Rob O'Grady's walk around Ruby Bay. Summary of findings.

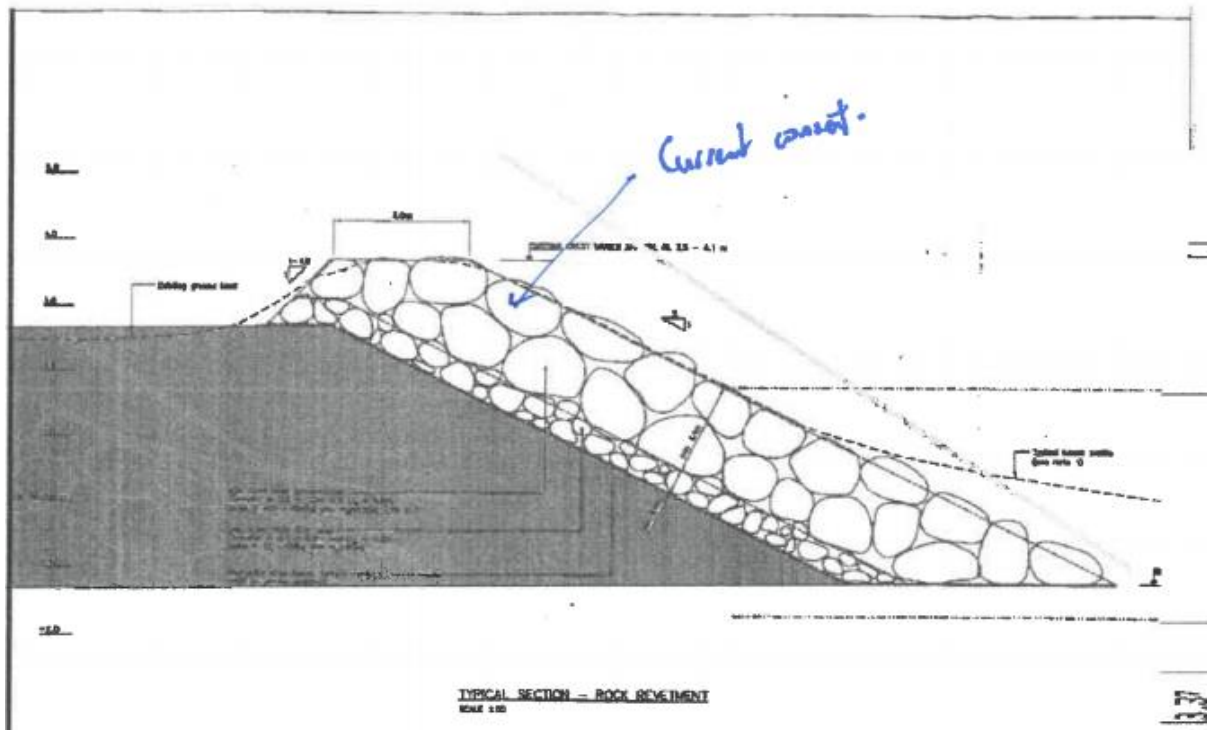
It was recounted that during Cyclone Fehi most of the flood water was generated by waves splashing up over the sea wall, as opposed to waves surging over the wall. It was suggested that if the water splashing over the sea wall could have flowed back through the sea wall then flood waters would not have accumulated to the same extent. The seawall effectively acted as a dam.

It was suggested that, if the part of the sea wall that extends above the walkway was made of large rocks with voids between, then water could flow through the seawall back down to the beach.

A drawing was presented which showed the sea wall design as per below. We were informed that this was a cross section as per the resource consent for the sea wall. It was suggested that if the wall was built as per this design then water could flow back through the wall via the voids between the rocks.

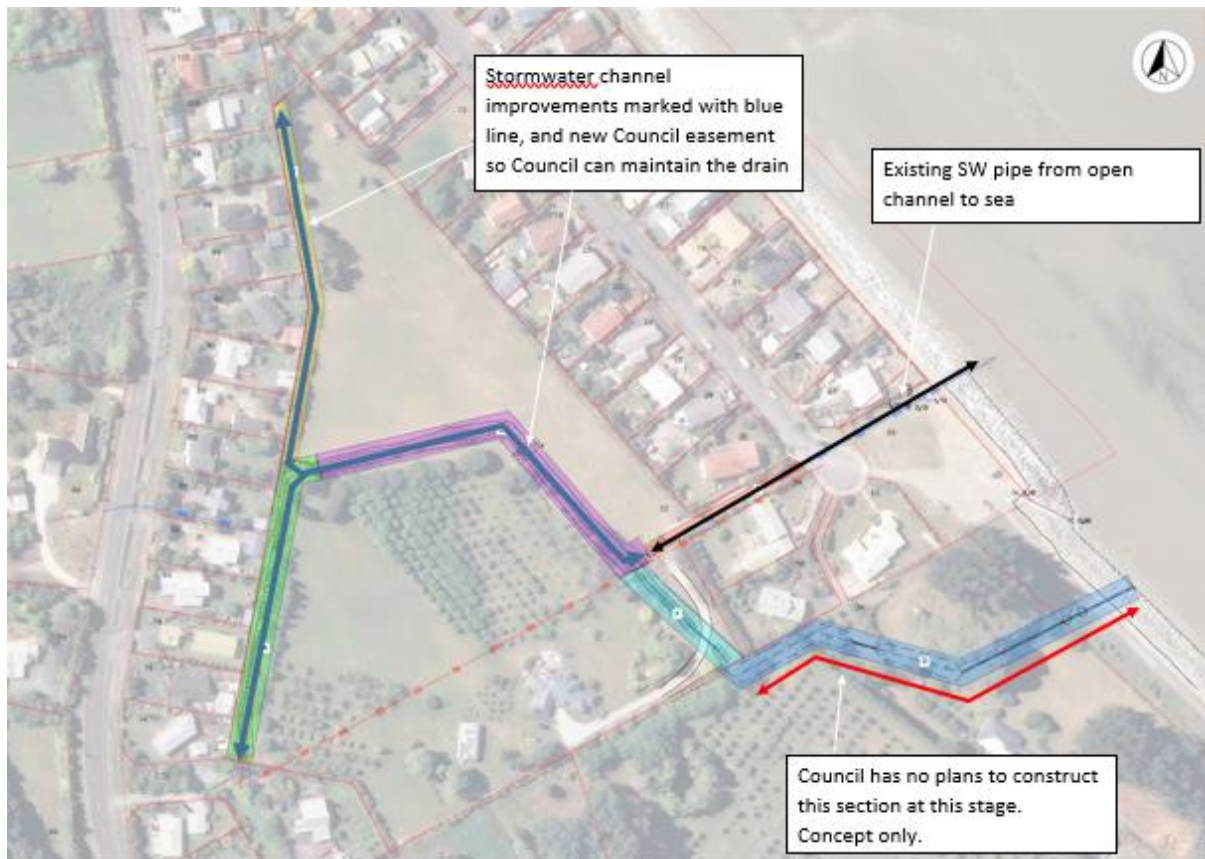
The concept plan that Council have prepared for a second outfall pipe via 38 Broadsea Ave was presented by the landowners that have been party to the easement negotiations (see below). I reported that it had been costed at \$350,000 by the design consultants, and would likely cost more once all costs [including resource consents etc] were factored in. I reported that there wasn't funding for a second outfall pipe and Council were not planning to construct a second outfall pipe at this stage. I reported that a catchment study was programmed for the area, which would better inform the situation with respect to flooding resilience. This would include assessing flow down to the estuary in a southerly direction during flooding. I reported that, even if a second outfall pipe was constructed, the main issue was that the area was low lying and there was inadequate fall to effectively drain the area to sea via overland and piped drainage.

Concern was raised that if there was a plan to direct water down towards the estuary that this would put more pressure on existing drainage out towards the estuary, which was already being pressured by intensification caused by development in Mapua.
